# **ERRATA SHEET**

**Date:** 2003 Aug 01  
**Document Release:** Version 1.0  
**Device Affected:** P89LPC912

Figure 1: Flowchart ICP Global Erase

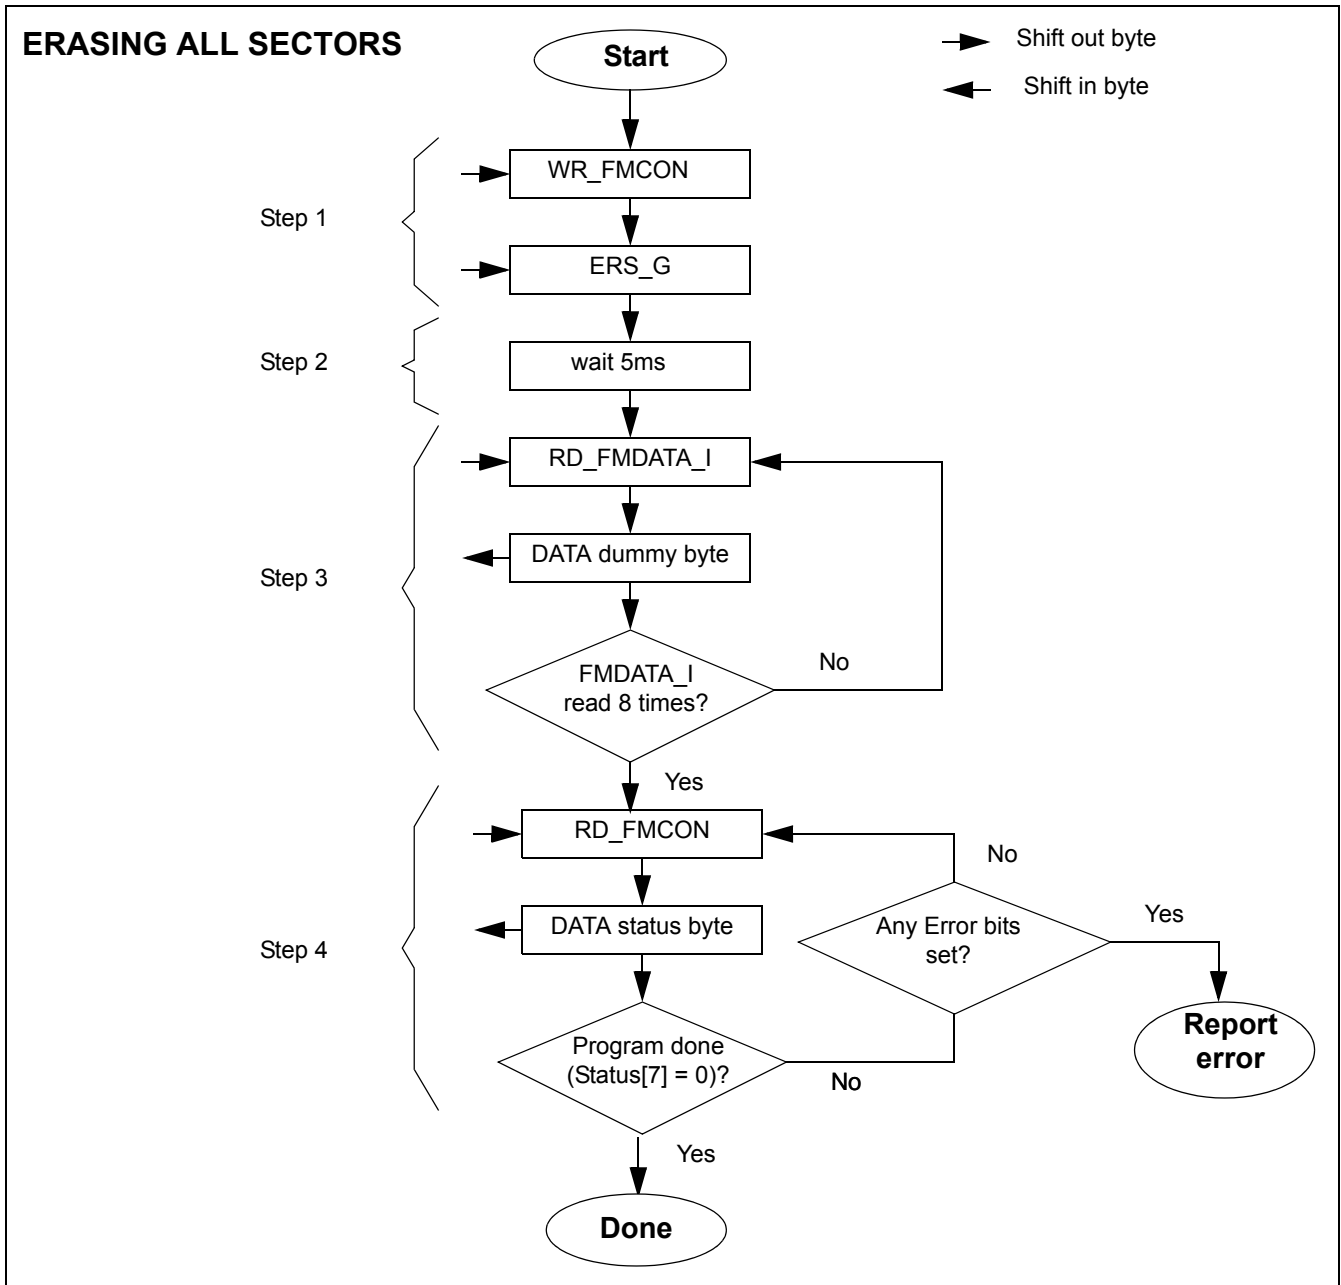
**Problem:** When giving the Erase Global command through the ICP interface the LPC912 will not clear the busy flag and stay busy forever.

**Workaround:** The workaround can be done in 4 steps:

Step 1: Shift out the WR\_FMCON command followed by the Erase Global opcode.

Step 2: Wait 5ms.

Step 3: Do 8 dummy reads with the RD\_FMDATA\_I command.

Step 4: Read FMCON until the busy flag gets cleared.

Please also see figure 1 on the following page.
